**Certificate of Appropriateness for work in the
Historic Districts: 325 N. 9th St. and 328 N. 8th St.**

**Historical Architectural Review Board
COA Final Review Sheet**

HDC-2023-00012

HDC-2023-00013

Image of proposed garage door.
(Applicant)

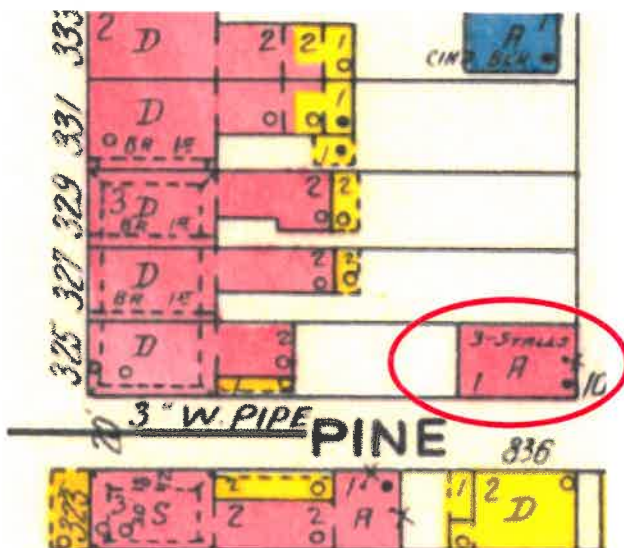
The installation of overhead garage doors will require the removal of the existing jambs, though the doors have simple jambs with no thresholds or transoms. Staff recommends adding glazing in the top third or half of the doors to maintain the solid-to-void ratio and comply with Guideline 3.6.6. Staff contends that alternative materials are acceptable at an accessory structure and asks that the applicant consider a more appropriate composite door system with vertical panels and glazing to comply with Guideline 3.6.9. However, staff recommends that the HARB take the previously approved paneled metal door into consideration.

Denial of the application as presented, but approval of a vertically paneled metal or composite door with glazing, with the staff to review details, pursuant to Chapter 3, Section 3.6 Doors.

Mr. Jordan asked whether the proposal is for three separate doors in three existing spaces or if it would be for one large door. Mr. Sibri responded that it would be three separate doors. He explained that the doors cannot be opened, because the structure is unstable and that the roof had collapsed while he was working on the building. He added that he requested a door with some design element that respects the original doors, though he noted that he needs to work within a budget.

Mr. Jordan opined that the scale, massing, and structure were more important than whether the doors contained glazing. Mr. Lichtenwalner contended that it would be difficult to match the proportions of the glazing in the garage door and that the windows would not pay respect to the historic value of the existing doors. He then questioned whether the door would maintain similar proportions to the example shown, noting that the sample shows a much wider door. He asked whether the smaller opening would significantly change the design. Mr. Sibri responded that the door company explained that the door would be custom made to fit the opening.

that symmetry would be an important feature of any new doors. He suggested that the doors be custom cut to be symmetric.

Mr. Encelewski moved to approve with conditions the application presented on 3/6/2023 for the installation of three garage doors at 325 N. 9th Street, as agreed to by the applicant and with the staff to review details, pursuant to Chapter 3, Section 3.6 Doors, provided the garage door openings are preserved and that the doors are cut symmetrically in design, noting that the brick piers present a unique circumstance. Mr. Hart seconded the motion, which carried with unanimous support.
